Work Session Memorandum

To: Salt Lake City Historic Landmark Commission

Re: **PLNHLC2018-00616 Construction of Hotel Building, Major Addition to Salt Lake Union Pacific Railroad Station and Demolition of Non-Contributing Structures at approximately 2 South 400 West**

SHEET NO.
A1.00

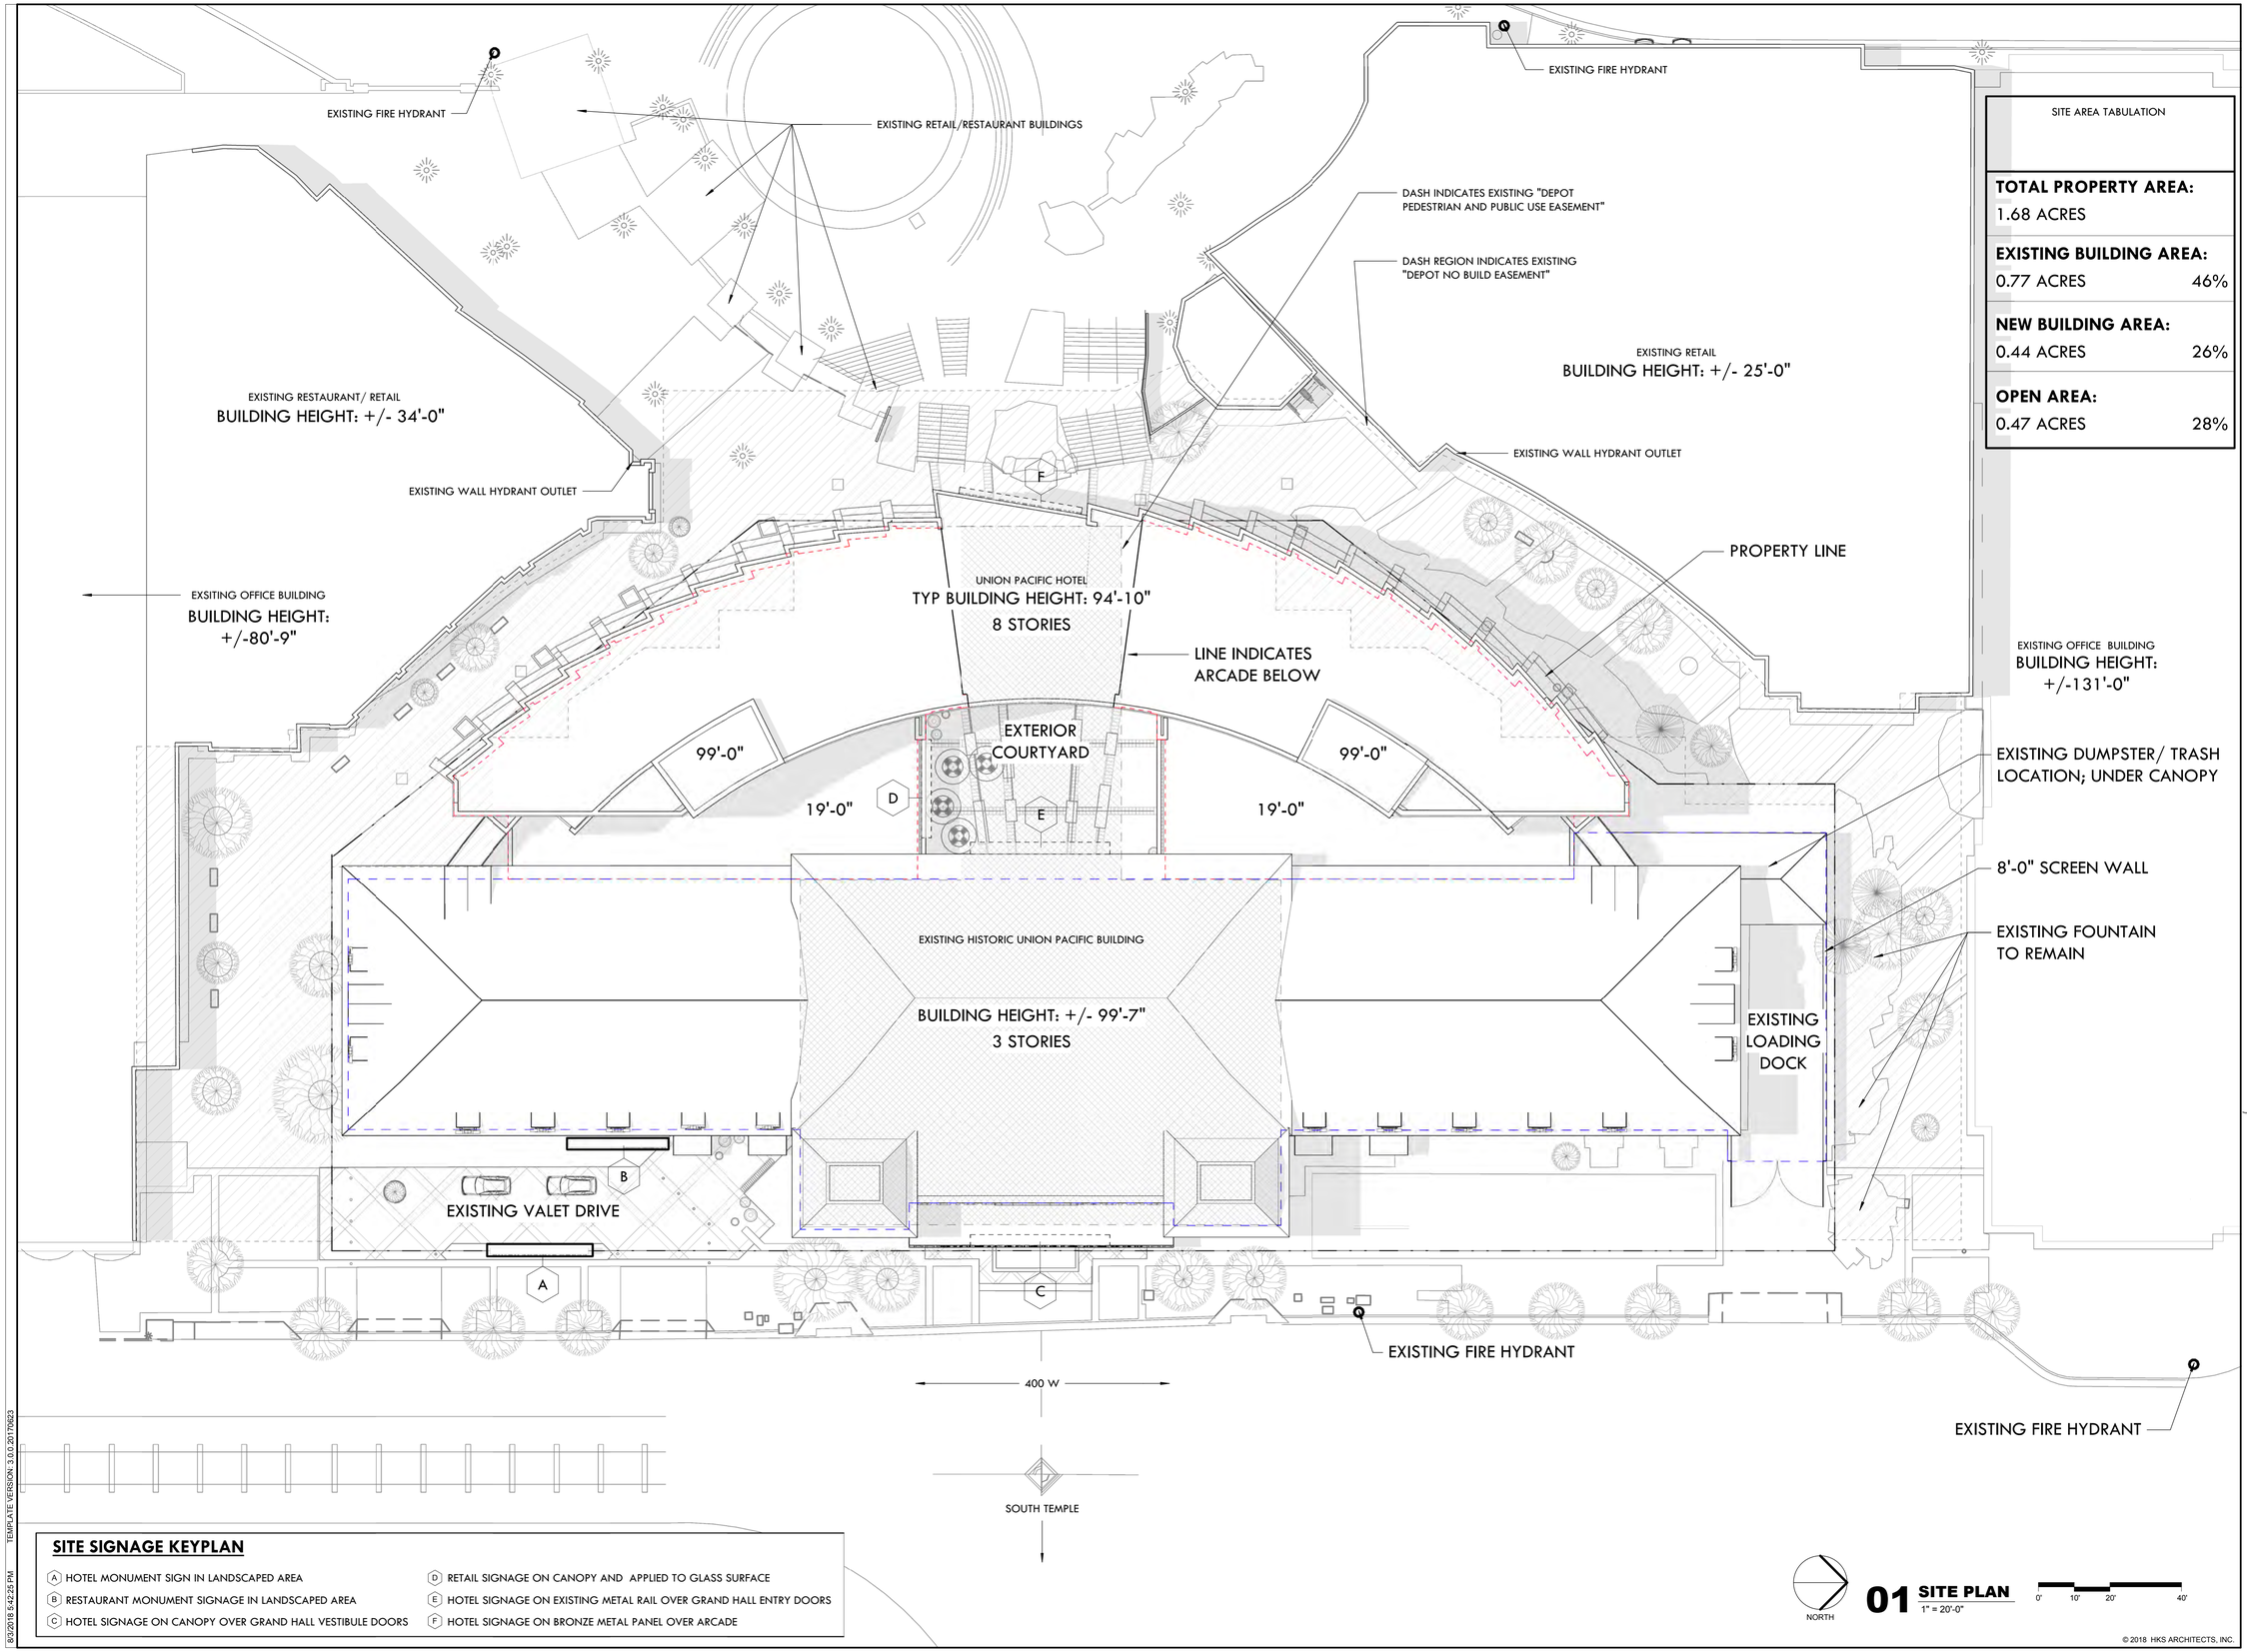
1. The architectural site plan appears to indicate that the building encroaches the property lines on the Northwest, West & Southwest. See sheet A1.00. This also may affect the unprotected openings in accordance with IBC 705.8.
2. The code analysis on sheet A0.01 indicates that the occupancy is R-2. Would the dwelling units contain cooking facilities? This question is being asked because R-2 hotels are non-transient as per IBC 310.4.
3. It is not clear as to how and where the firewalls (fire separations) between the new and the old building occur and what those fire ratings actually are.

SHEET NO.
A2.04

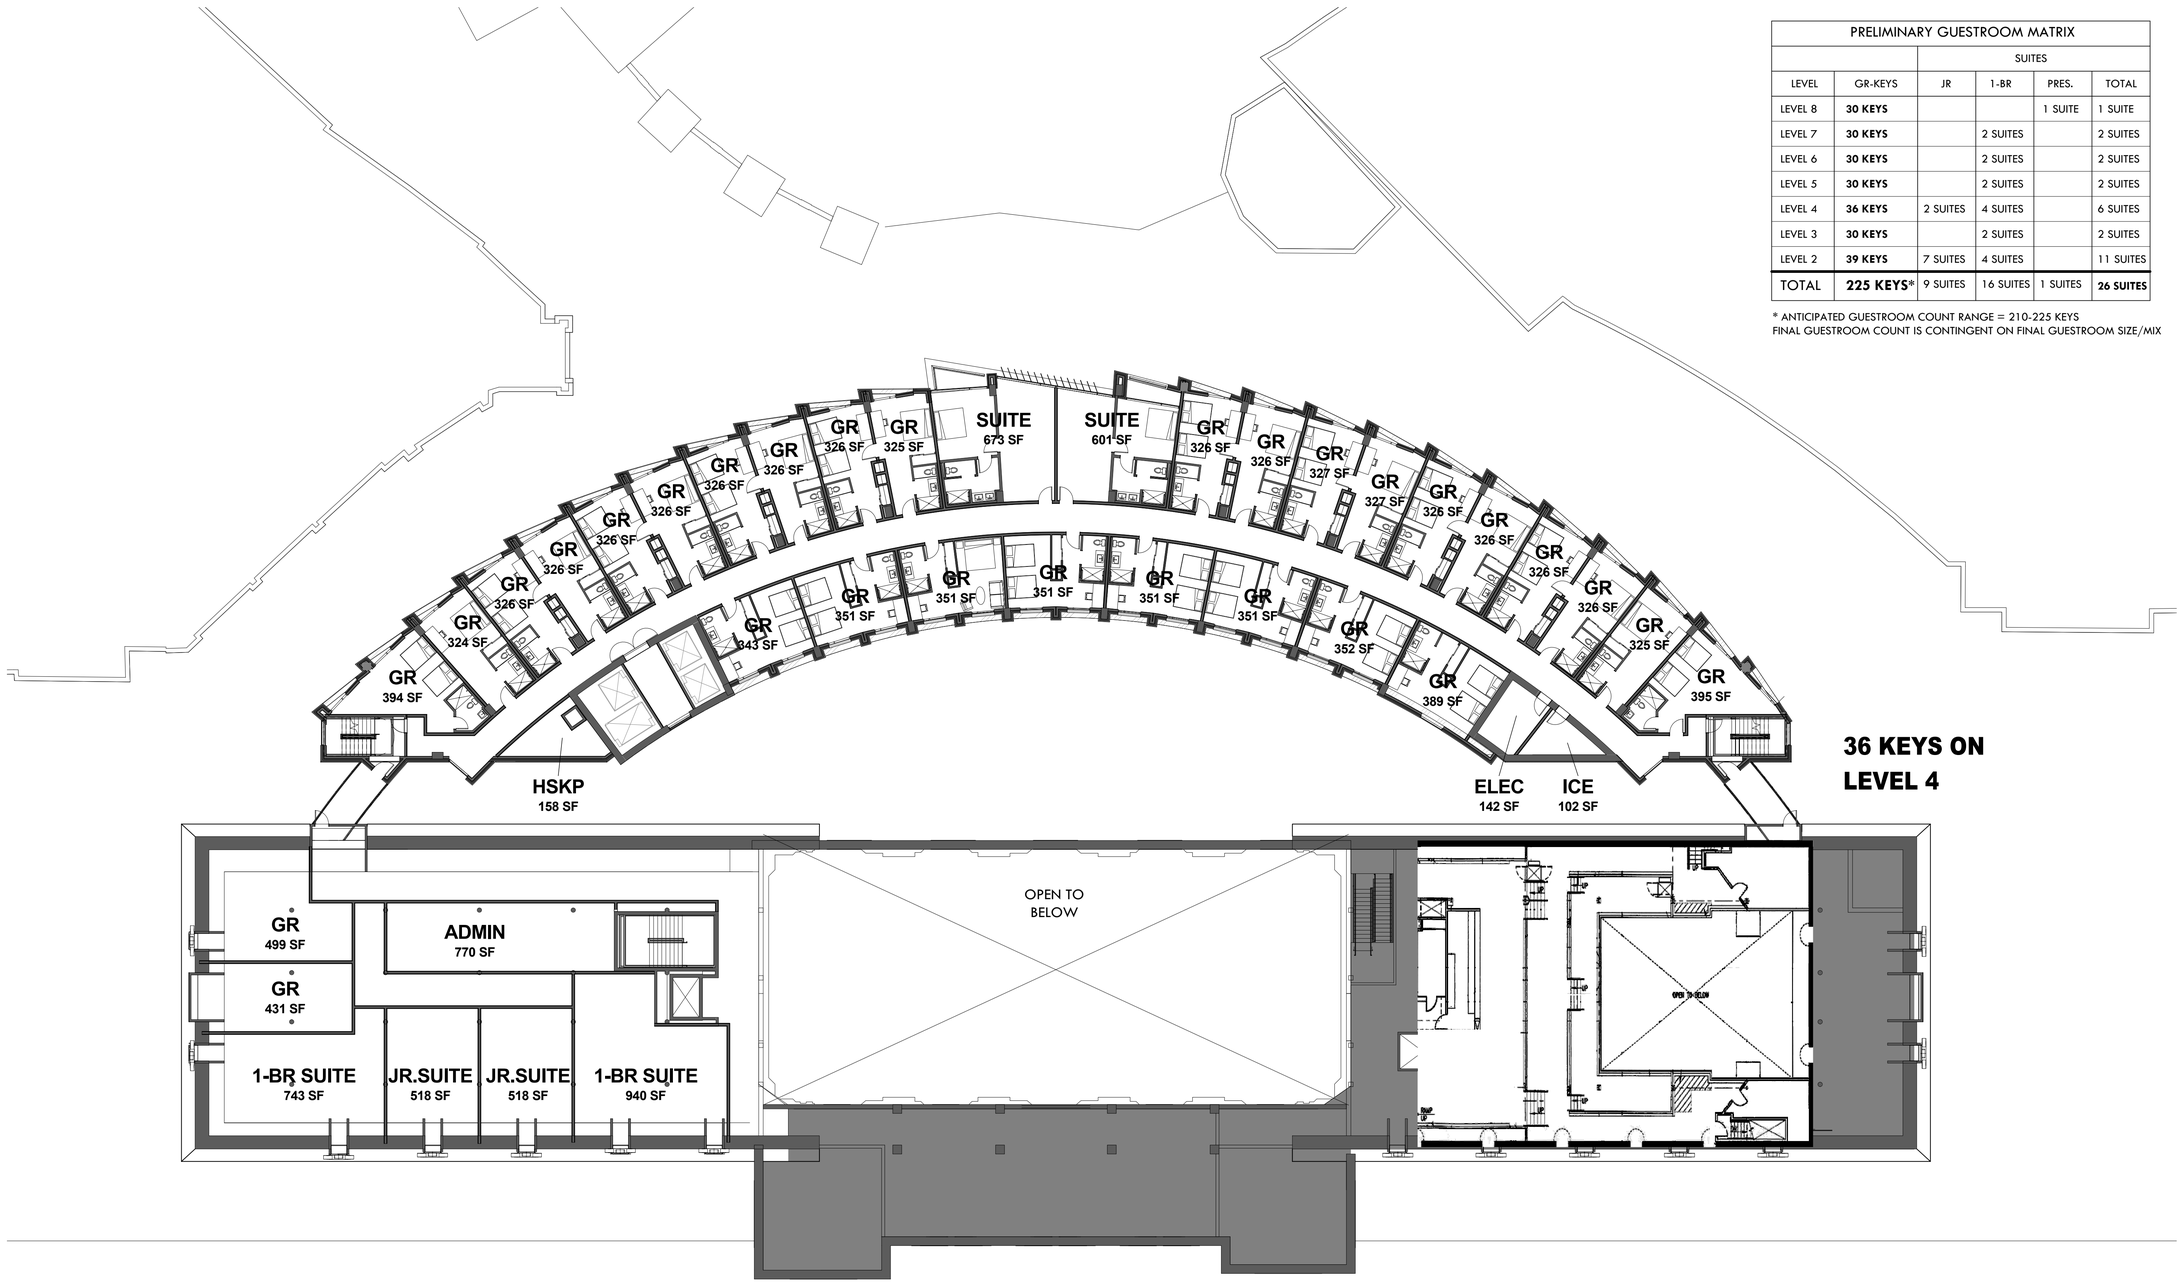
We have the following questions regarding the drawings for a meeting with the Fire Prevention Bureau.
• Where is the aerial apparatus access located at the east side of the existing building it does not show on drawings.
• The fire command center is not located on drawing A2.01.
• Horizontal exit wall is not provided in the high-rise building on drawing A2.02, through A2.08.
• Exiting for the board room and Specialty Bar shall have exiting to the north to the exit stair by a corridor see drawing A2.02.
• We question the length of a corridor which serves 1-BR Suite on drawing A2.04.
